JEFFERSON TOWNSHIP DEPARTMENT OF HEALTH Application for Permits

ALTERATION OF EXISTING
SEPTIC SYSTEM FOR 2 BED-
ROOM DWELLING AT
96 EAST SHORE ROAD
JEFFERSON TWP., N.J.
PREPARED BY: Paul T. Sabia

BLOCK <u>162</u>	SEWAGE: New ☐ Repair ☒
LOT <u>27</u>	86-146A
STREET _____	
NO. OF BEDROOMS <u>3</u>	WELL: New ☐ Deepen ☐
Owner: _____ Address: <u>7 E. Shore Rd.</u> Telephone: _____	
THIS APPLICATION WILL BE REVIEWED AND RETURNED WITHIN THE LEGAL TIME LIMIT OF 15 DAYS

for Addition of 1 Bedroom

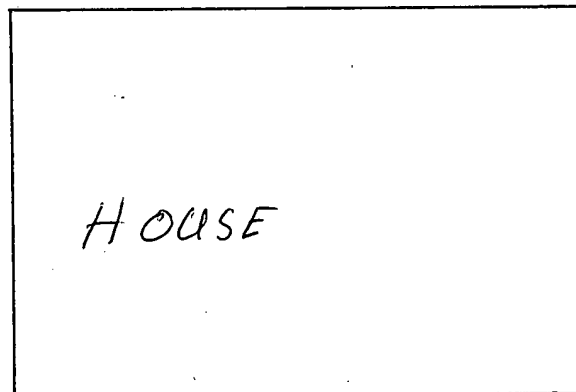
proposed
3'x6' seepage
pit

existing
6'x6' seepage pit

Advised owner that in order
to add bedroom, must upgrade
septic system by adding minimum
of 6' x 3' seepage pt.

To Final - 6' 6" x 3' pit connected to
existing system and
